**ALERT SERVICE BULLETIN**

**NO.** 212-01-112

**MODEL AFFECTED:** 212

**SUBJECT:** MAGNETIC BRAKE P/N 204-001-376-003, ONE TIME INSPECTION OF.

**FIGURE 1**

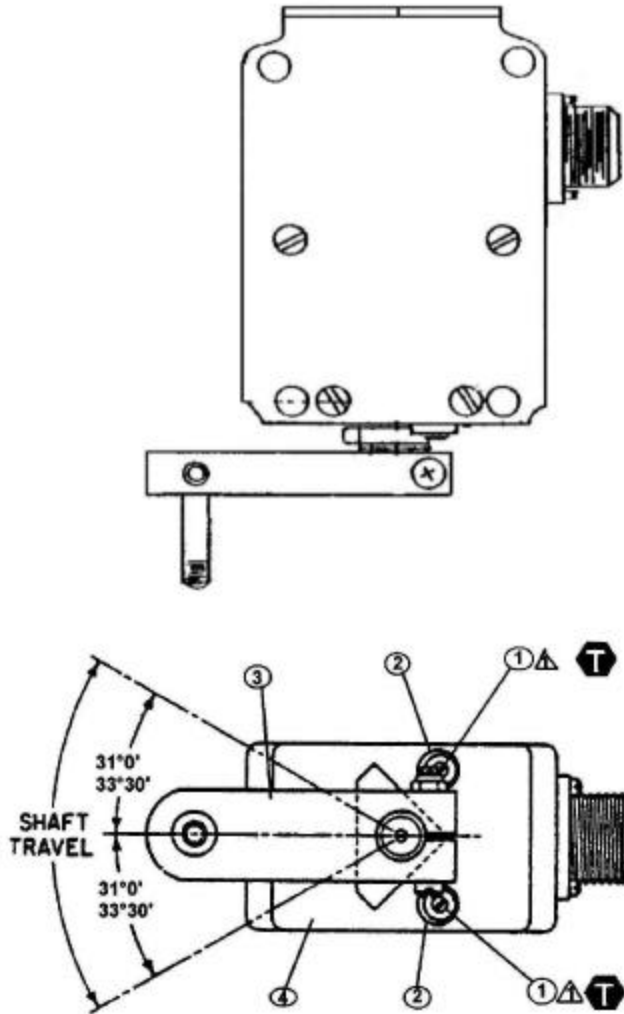
6. Using a suitable torque wrench and screw driver bit apply 10 inch/lbs(1.12 Nm) force to screw(s) (1 figure 1) in a counterclockwise direction. If screw(s) (1) do not move, proceed to step 12. If any movement is found on screw(s) (1) proceed to the following steps.

If the inspection reveals that screw(s) (1) has disengaged, inspect arm assembly (4) for mechanical damage created by screw (1). If mechanical damage is found, the depth shall not exceed 0.030 inch (0.762 mm). Acceptable damage may be smoothed and treated in accordance with the Standard Practice Manual Chapter 3 for Chemical Film. If damage is greater than 0.030 inch (0.762 mm) contact Product Support Engineering.

7. Remove screw(s) (1) and stop limit(s) (2) from magnetic brake (4).
8. Clean residue adhesive from magnetic brake (4) screw holes and screw(s) (1) with compressed air.
9. Apply adhesive (C-320) to screw (s) (1) threads and install in magnetic brake (4) hand tight.
10. Adjust the stop limit(s) (3) to achieve the arm assembly shaft travel as per dimensions in BHT-212-MM Maintenance Manual, Chapter 67.
11. Once shaft travel is obtained, torque screws (1) 5 to 10 in-lbs (0.56 to 1.12 Nm).
12. Apply torque seal inspection ink to screws (1) and to stop limits (2).
13. Re-install cyclic fore & aft and lateral magnetic brakes into aircraft.
14. Re-install cyclic and anti-torque magnetic brake access panels.
15. Connect battery.
16. Make an entry in the helicopter historical records indicating compliance with this Alert Service Bulletin.

-  Bond screw with adhesive C-320
-  5 to 10 IN-LBS  
(0.56 TO 1.12 Nm)
